Access Compliance Report

Public Rights-of-Way

(Curb Ramps)

Intersection ID: 2909	Main Street: EASTFIELD_RD	Cross Street: EASTFIELD_RD	Location:	E
ADA ID: E3796AD99CEB	Ramp Type: Perp	Initial Pass/Fail: Fail	Overall Compliance: No	Severity Score: 10

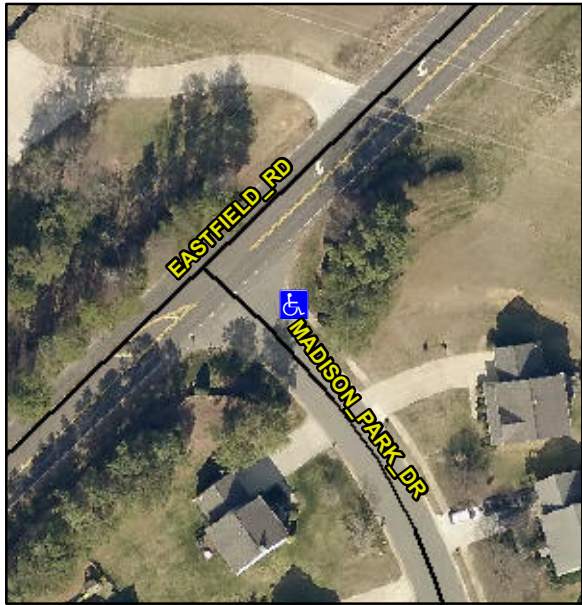
Codes/Mitigation Info/Possible Solution			Field Measurements/Component Compliance					
	Possible Solutions:		Compliance	Description	Data	Compliance	Description	Data
	Remove & Replace Entire Ramp.		N/A	Ramp Length (in)	45.0	Yes	Ramp Slope (%)	7.7
			No	Ramp Width (in)	46.0	No	Ramp XSlope (%)	2.6
			N/A	Flare Type LT	N/A	N/A	Flare Type RT	N/A
			N/A	Flare Slope LT (%)	N/A	N/A	Flare Slope RT (%)	N/A
			N/A	Flare Traversable LT?	N/A	N/A	Flare Traversable RT?	N/A
			N/A	Landing Length (in)	N/A	N/A	DWS Provided?	N/A
			N/A	Landing Width (in)	N/A	N/A	DWS Contrast?	N/A
			N/A	Landing Slope (%)	N/A	N/A	DWS Length (in)	N/A
			N/A	Landing X Slope (%)	N/A	N/A	DWS Full Width?	N/A
Surveyor Notes:			N/A	Landing Curb? (Y/N)	N/A	N/A	DWS Offset (in)	N/A
N/A			N/A	Shared Landing?	N/A			
PROW/ADA:			N/A	Gutter Ponding?	N/A	N/A	Gutter Slope (%)	N/A
R304.5.1, R304.5.3			N/A	Gutter Lip Ht (in)	N/A	N/A	Gutter X Slope (%)	N/A
			N/A	Painted X Walk1?	No	N/A	Painted X Walk2?	N/A
